OPERATING AND SERVICE MANUAL

11683A Range Calibrator

MANUAL CHANGES

Model Number: HP 11683A
Date Printed: January 1980
Part Number: 11683-90005

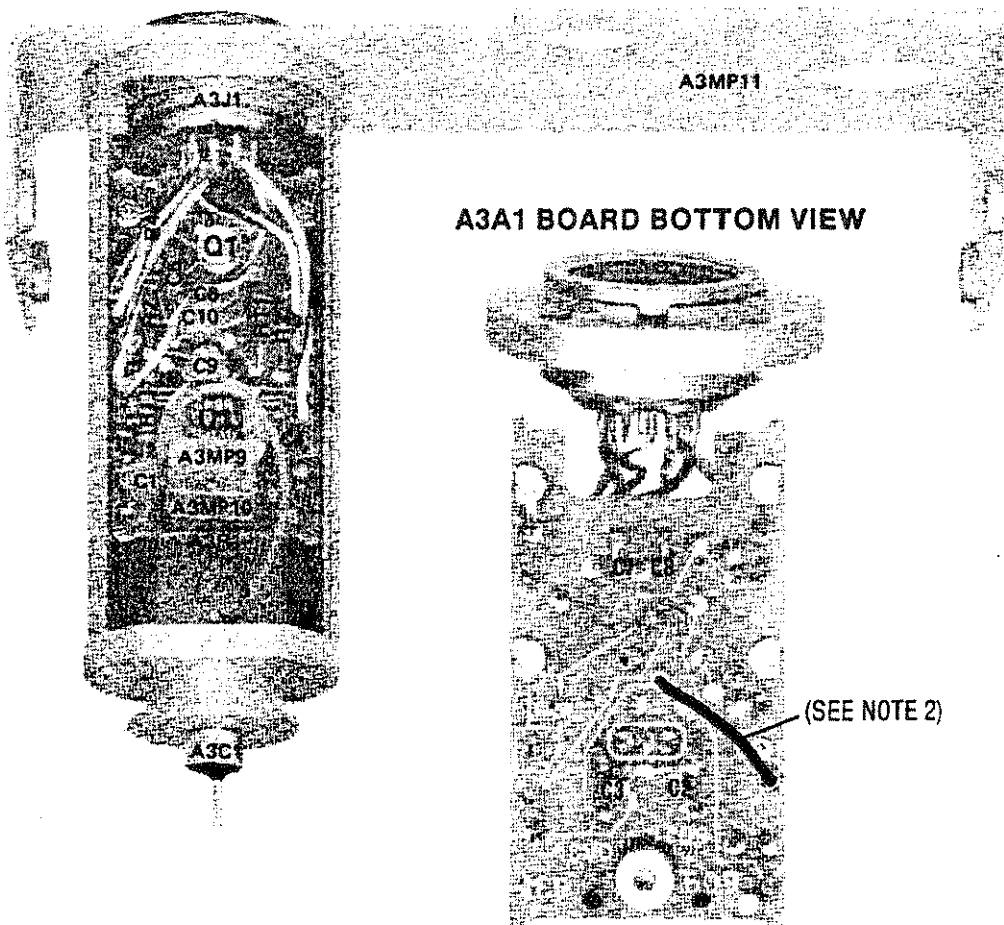
Page 25, Figure A3 (bottom of page):

Add the following notes to Figure A3:

1. Reference designations within this assembly are abbreviated. Add assembly number to abbreviation for complete designator.
2. Unless otherwise indicated, resistance is in ohms and capacitance in microfarads.
3. A capacitor may be found in only one of the two locations shown for A3A1C2 or it will be omitted. *(Errata)*

Figure 14. Power Supply Schematic Diagram

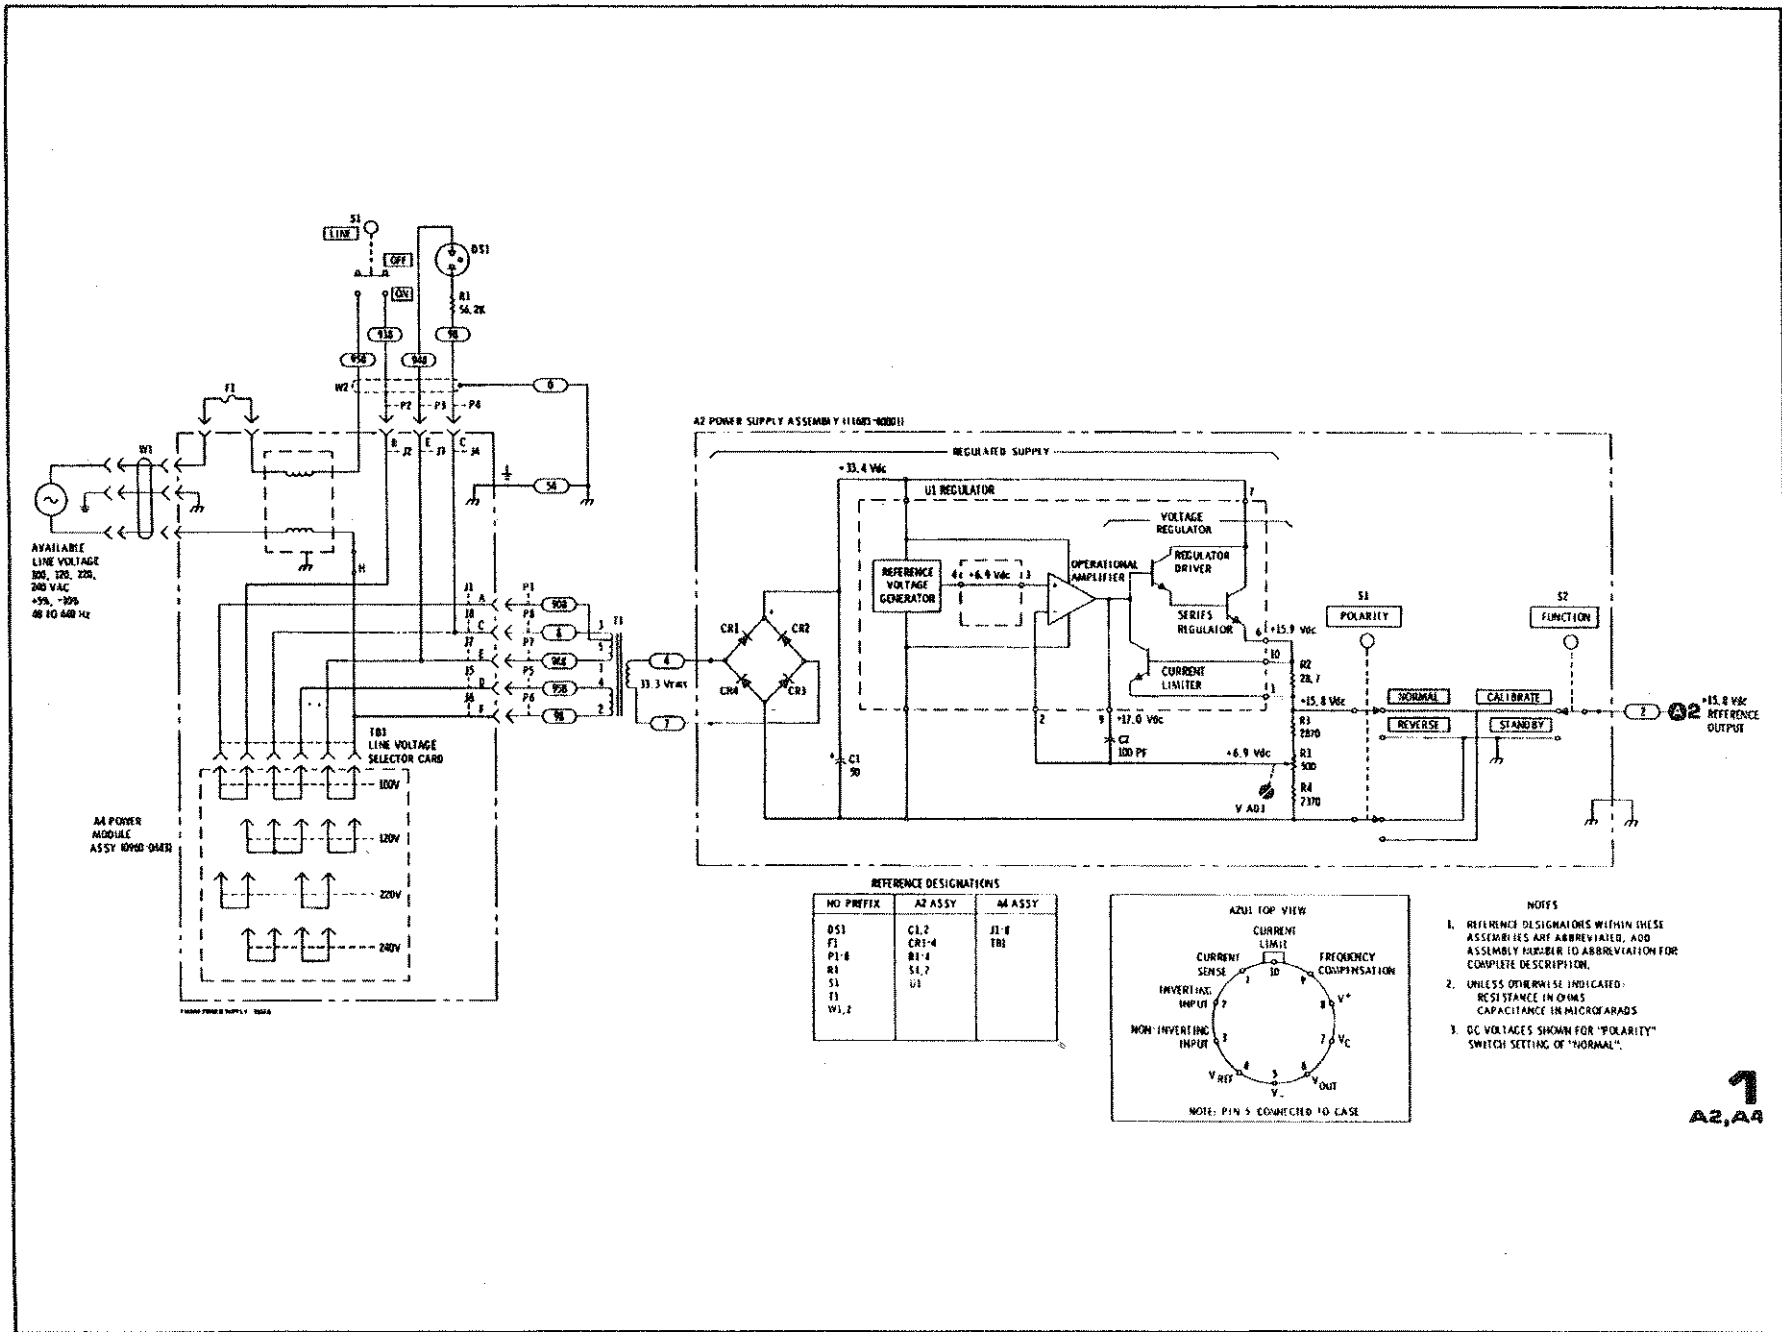
Page 19, Figure 14:

Change the line frequency information (left side of schematic) to the following:

For 100 and 120 Vac--48 to 66 Hz or 360 to 440 Hz at 125 mA

For 220 and 240 Vac--48 to 66 Hz at 62 mA (*Errata*)

Figure 15. A3 Assembly Component Locations

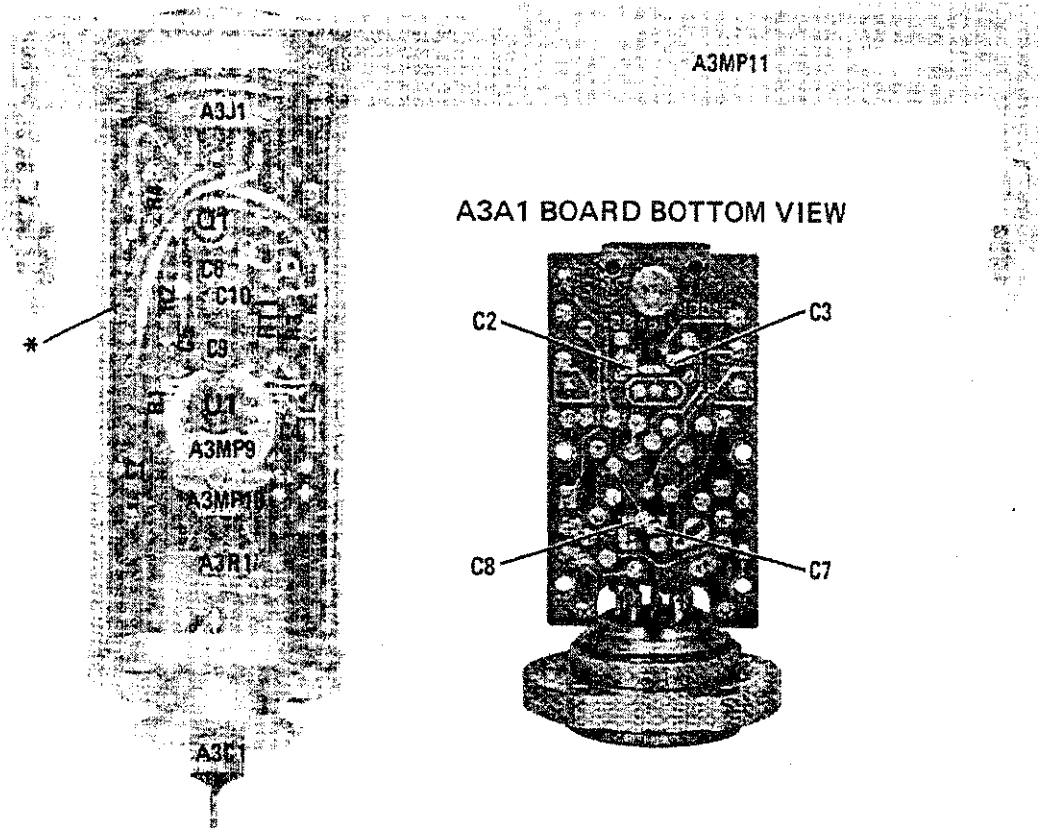
Page 20, Figure 15:

Replace Figure 15 "A3 Assembly Component Locations" with the new Figure 15 in this change sheet. (*Change 4*)

NOTE 1: A3 COMPONENT REFERENCE DESIGNATIONS ARE PRECEDED BY "A3". ALL OTHER COMPONENTS ARE PART OF THE A3A1 BOARD.

NOTE 2: WHEN THE A3A1 ASSEMBLY IS REPLACED AN INSULATED JUMPER WIRE MUST BE ADDED BETWEEN GUARD AND SIGNAL GROUND.

Figure 15. A3 Assembly Component Locations (Part of Change 4)

Figure 16. Range Switch/Sampling Gate Schematic Diagram

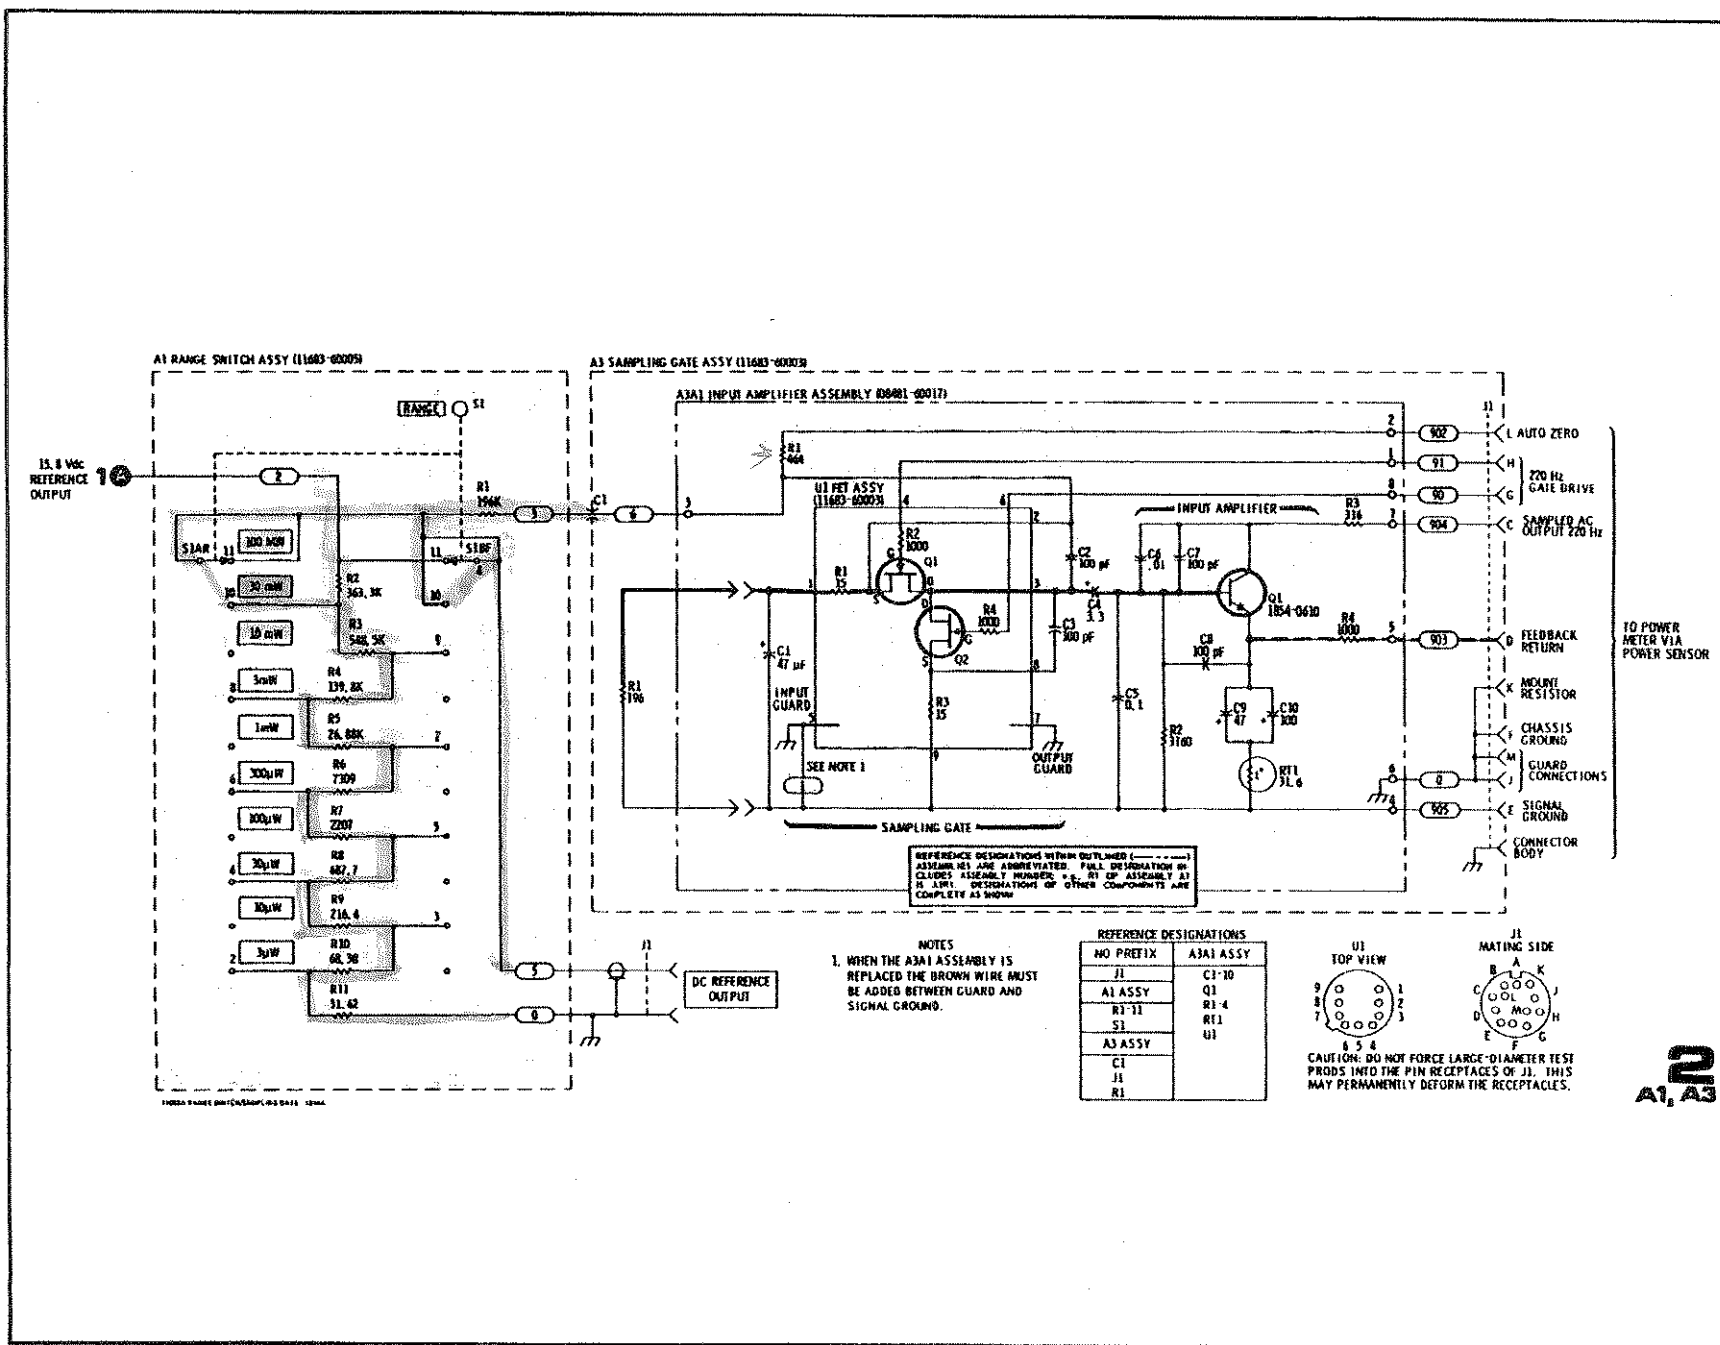
Page 21, Figure 16:

Change the part number of the A3A1 assembly to 08481-60025. *(Errata)*

Change the value of R1 (left side of A3A1 assembly) to 464k. *(Errata)*

Delete the connection of C1 to U1 pin 1 (left side of A3A1 assembly). *(Errata)*

Connect the positive side of C1 to the SOURCE (S) of U1 on the A3A1 assembly. *(Errata)*

At J1 (right side of schematic) add pin A. Connect pin A to the junction of pins F, M and J. *(Change 1)*

At J1 (right side of schematic) remove the line connecting pin A to pins F, M and J. *(Change 2)*

Figure A2. Assembly Component Locations

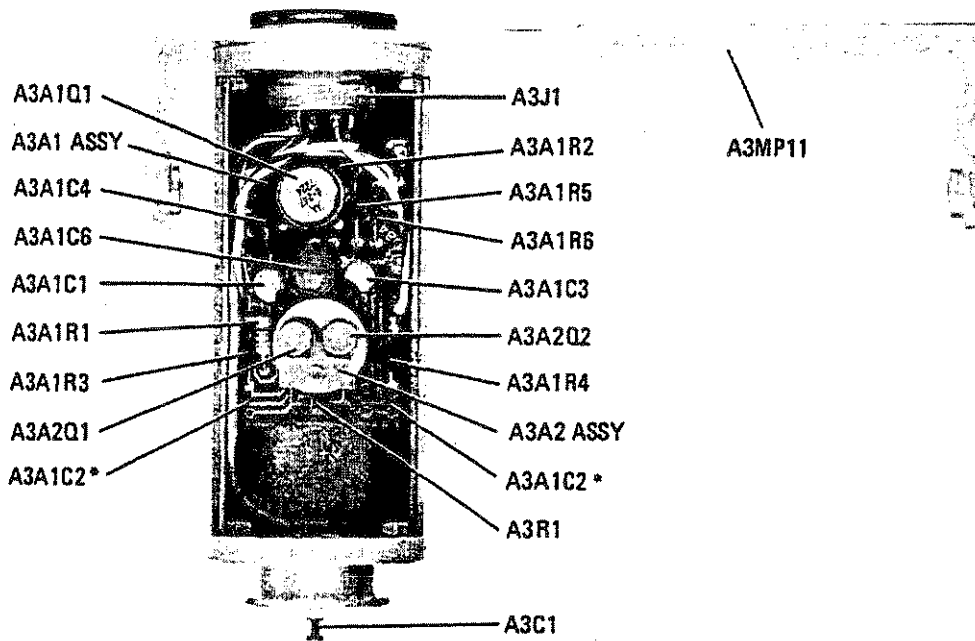
Page 20, Figure 15:

Replace Figure 15 with the one below:
